# Staff Report

**REPORT NO.:** DSD-2024-445

**SUBJECT:** Heritage Permit Application HPA-2024-V-024  
115 Lancaster Street East & 58-60 Ellen Street East  
Alterations to the Existing Building  
Construction of a 3-Storey Addition

Figure 6. Proposed Front (south) facade

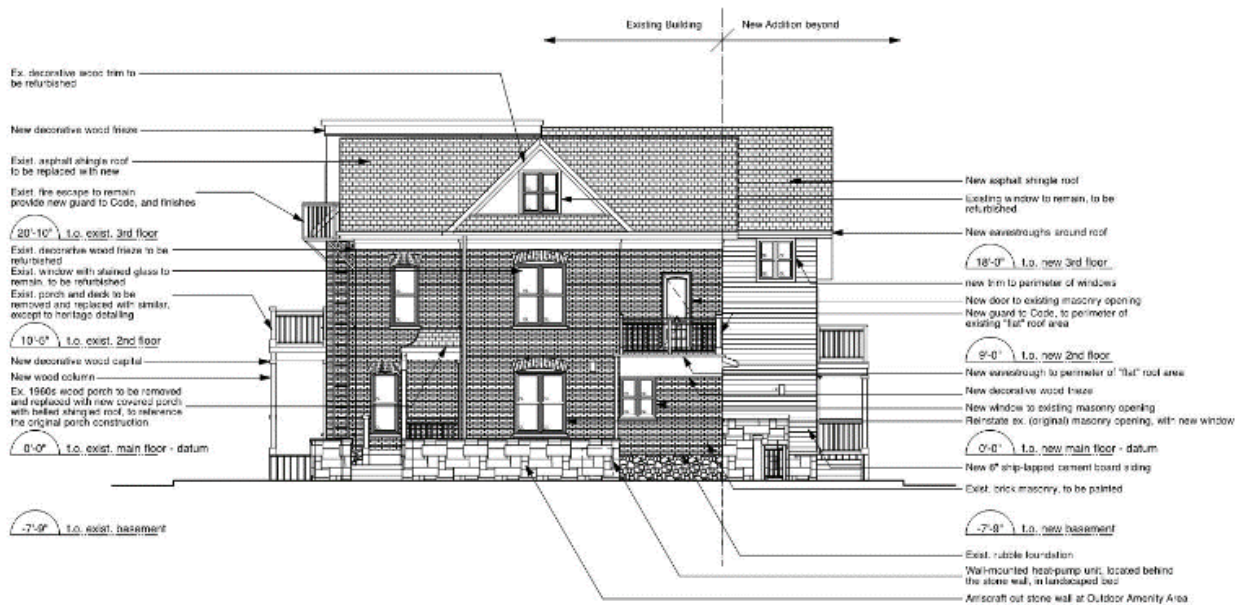
- Retaining and restoring the multi-panes, colour glass sash window located on the upper storey, which was identified as a heritage attribute

- Enlarging an existing lower-storey window opening to reinstate original masonry opening.
